**STATE OF MAINE
PUBLIC UTILITIES COMMISSION**

Docket No. 2008-255

**CENTRAL MAINE POWER COMPANY
and
PUBLIC SERVICE OF NEW HAMPSHIRE
Request for Certificate of Public Convenience
and Necessity for the Maine Power Reliability Program
Consisting of the Construction of Approximately
350 miles of 345 kV and 115 kV Transmission Lines ("MPRP")**

Direct Testimony of Robert Fagan

Figure 1. Maine Zone FCM Price Projections

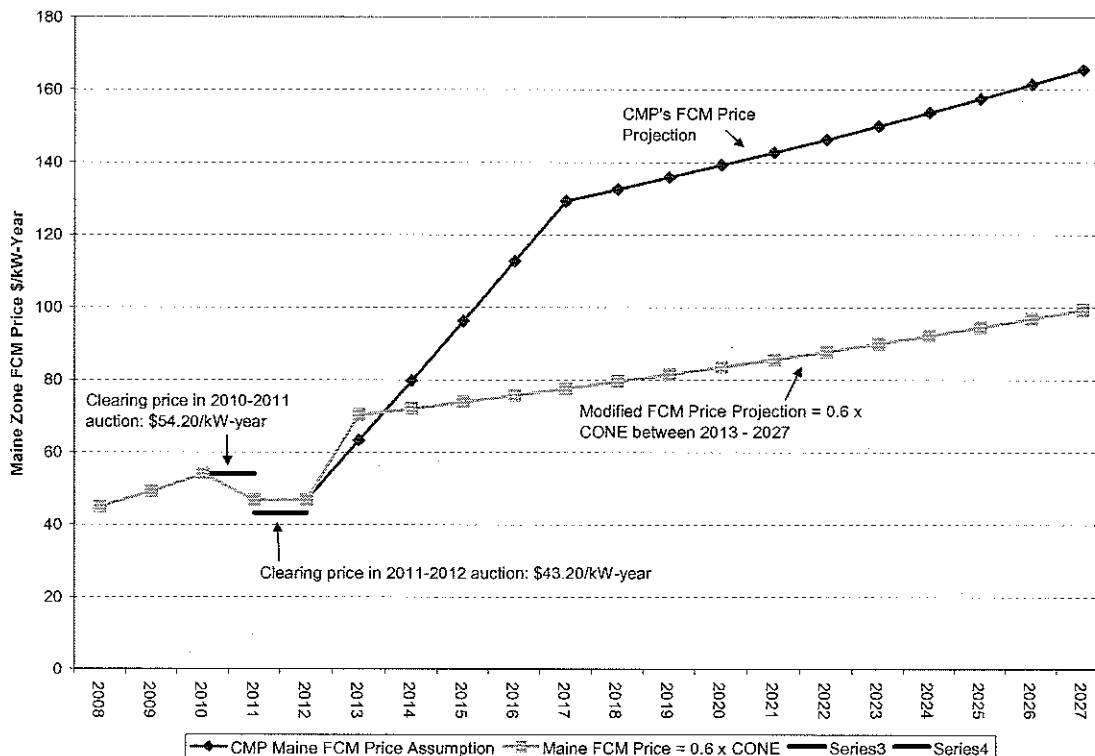
9 A. I made these changes by modifying the spreadsheet values in two different
10 worksheets contained in the NTA v2 file provided as an attachment to the
11 response to EX-07-07. The file and worksheet I first modified was MPRP
12 Scorecard Model v10 – ME – NTA v2.xls. I modified the FCM quantity
13 obligation by reducing the Maine summer peak load MW obligation by the
14 cumulative quantity of summer generation provided by the NTA generation
15 commencing in 2012. These changes were done in the "Maine LSE Items"
16 worksheet. I then modified the "NTA Generation" worksheet by setting the
17 "FCM/FRM" revenue total to zero. These two changes reflect the "Scenario 1"
18 modifications noted above. For "Scenario 2" noted above, I kept the same
19 changes as for Scenario 1, and added a further change by modifying the FCM
20 price input assumption on the "inputs" worksheet to the same file. In that case, I

21 set the FCM price to equal CMP's FCM price through year 2012, and then
22 commencing in 2013 I set the FCM price equal to 0.6 times CMP's computed
23 value of "cost of new entry" or CONE. Figure 1 below shows the modification to
24 the FCM price pattern that I used for Scenario 2, along with CMP's FCM price
25 projection.

Figure 2. Illustrative Rate Impacts Using CMP Model, 2008-2027

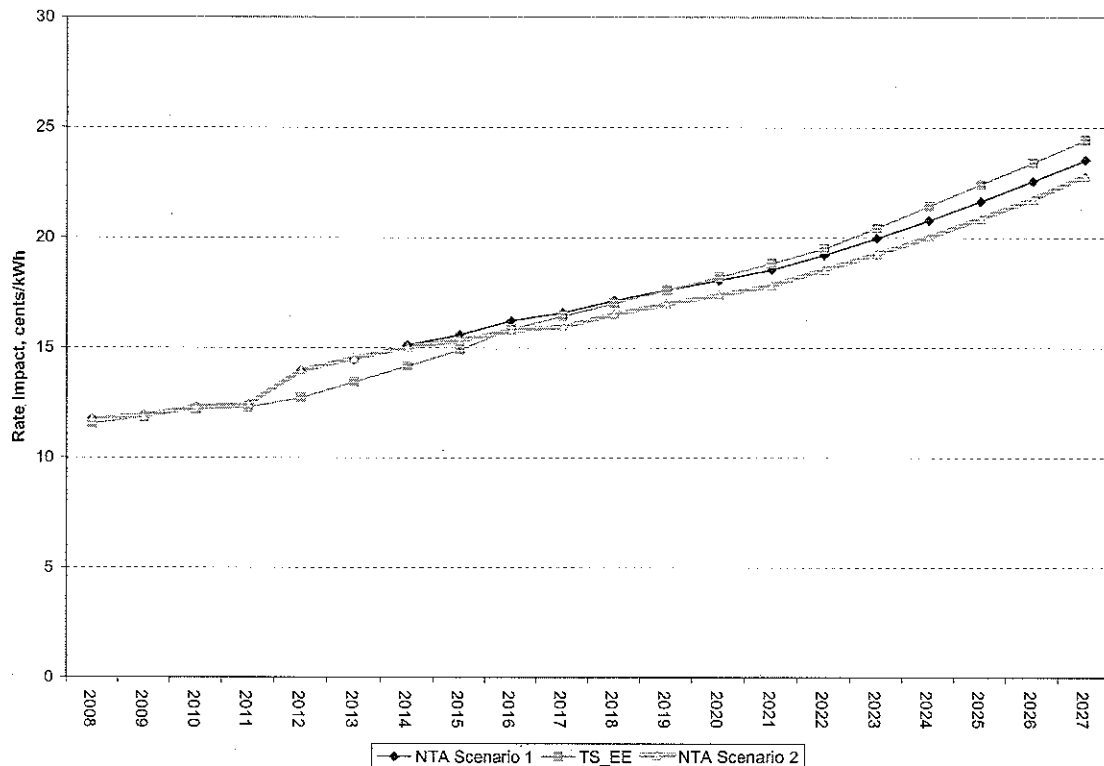
17 A. Yes. Figure 2 below illustrates the comparative rate impacts using CMP’s model
18 for those illustrative impacts.
